34 Pasture Road, Letchworth Garden City

Report to:	Advisory Management Committee			
	Advisory Managomonic Committee			
Date of Meeting:	11 th May 2023			
Agenda Item:	6 b)			
Applicant				
Application for:	An application for: Replacement roof, front two and rear single storey extension including external cladding and replacement windows.			
Tenure:	Scheme of Management			
Author:	Christopher Shipman – Heritage Advice Service			
Location:	34 Pasture Road			
Appendix A				
Status:	For Decision:			
	Yes			
Character Area/HoSI:	Modern Character			
	Area

34 Pasture Road (39536) – Replacement roof, front two and rear single storey extension including external cladding and replacement windows

Similar anchoring plot on Pasture Road with a design similar to that proposed for no34

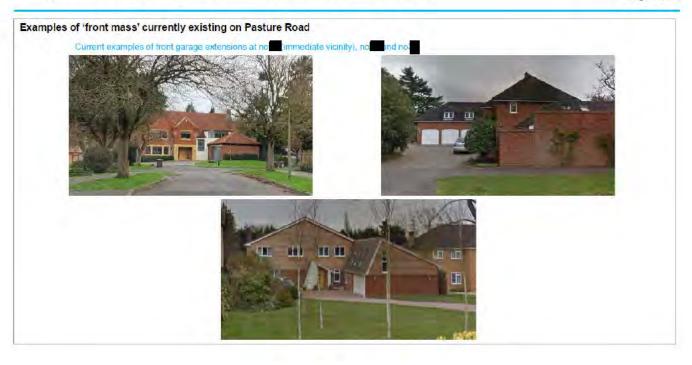
- Considering the existing Pasture Road property at no18 (anchoring a similar plot position to no34 on the adjacent corner, also a road
 facing corner, arguably of greater visibility & prominence when compared to no34) illustrates that garage / front extension designs
 similar to that being proposed have been accepted and approved in the past. When looking at no18 (triple garage scheme), it is fair to
 highlight that the proposal for no34 is of a lower mass, less prominence and more in keeping with the overall scheme being proposed.

of similar design, if anything of greater mass and prominence when compared to the no34 proposal
